Project: West Glen
Plan preparer: Mike Myers, Dominion Engineering [172 S. Pantops Drive
Charlottesville, VA 22911, mmyers@dominioneng.com]
Owner or rep.: Crozet Development Solutions LLC
1215 E. Market Street, Suite B / Charlottesville, VA 22902-5512
Plan received date: 10 Feb 2016
(Rev. 1) April 6, 2016
Date of comments: 27 Feb 2016; revised 11-Mar 2016
(Rev. 1) May 6, 2016
Reviewer: John Anderson
Project Coordinator: Rachel Falkenstein

SP201600003

Engineering comments:

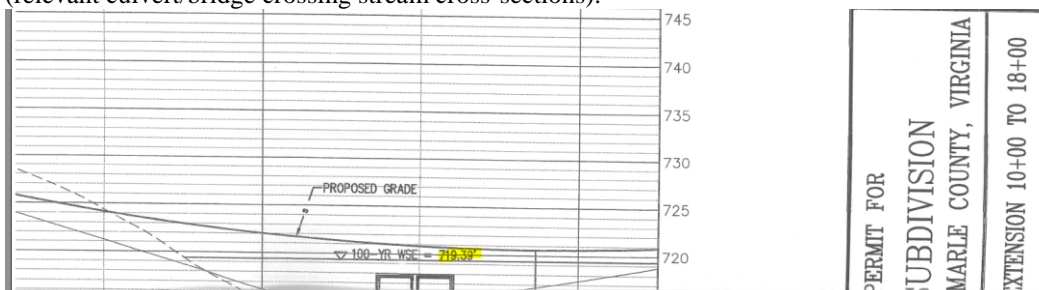
1. Attached FEMA Firmette (Map Panel 51003C0229D) shows Zone AE base elevation at FIS cross-section 'I' is 715±. Ref. SP5. SP7 Cling Lane Extended Profile shows 100-yr WSE = 719.39'. This, if accurate, represents rise in BFE at proposed 12'W × 8'H double box culvert, Road Sta. = 17+48.73. FIS is assumed accurate, and includes Jarmans Gap Road, SR 691. This proposal if advanced in current form would require FEMA Conditional Letter of Map Revision/Fill. [CLOMR-F; Ch. 18-Sec. 30.3.10.A.3.] [Plan / below] **(Rev. 1) Addressed.** Ref. Sheet SP8: Proposed 10'W × 10' H triple box culvert (countersunk). Sheet 11, Existing /Proposed Modeled conditions show 'No Rise' in BFE at stream cross-sections I, H2, H1, H (relevant culvert/bridge crossing stream cross-sections).

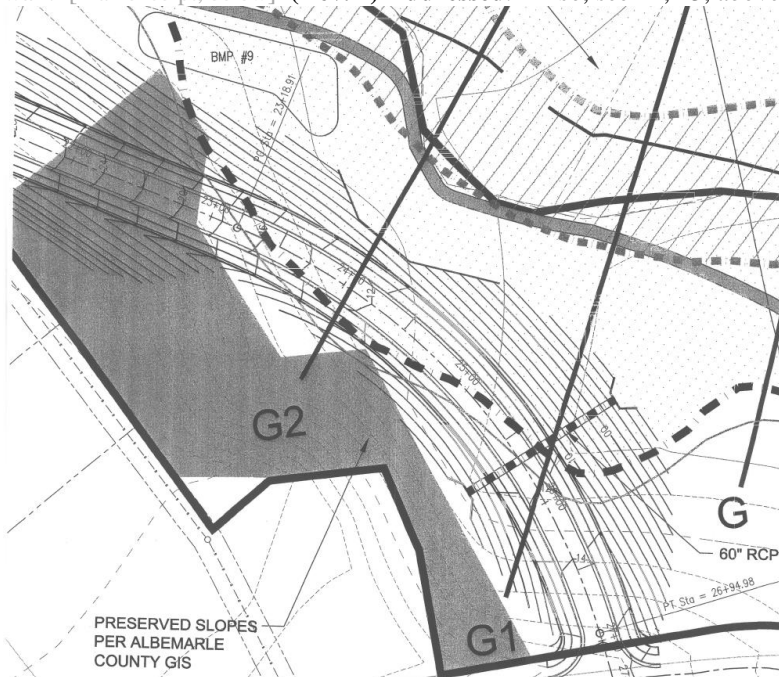
14. SP5/SP6 –Provide (H&H analysis) cross-section upstream of connector floodway fringe/retaining wall. Evaluate effect of proposed (floodway fringe) fill required to construct roadway embankment/retaining wall. [Plan excerpt, below] **(Rev. 1) Addressed.** –Also, see #2, 13, above.
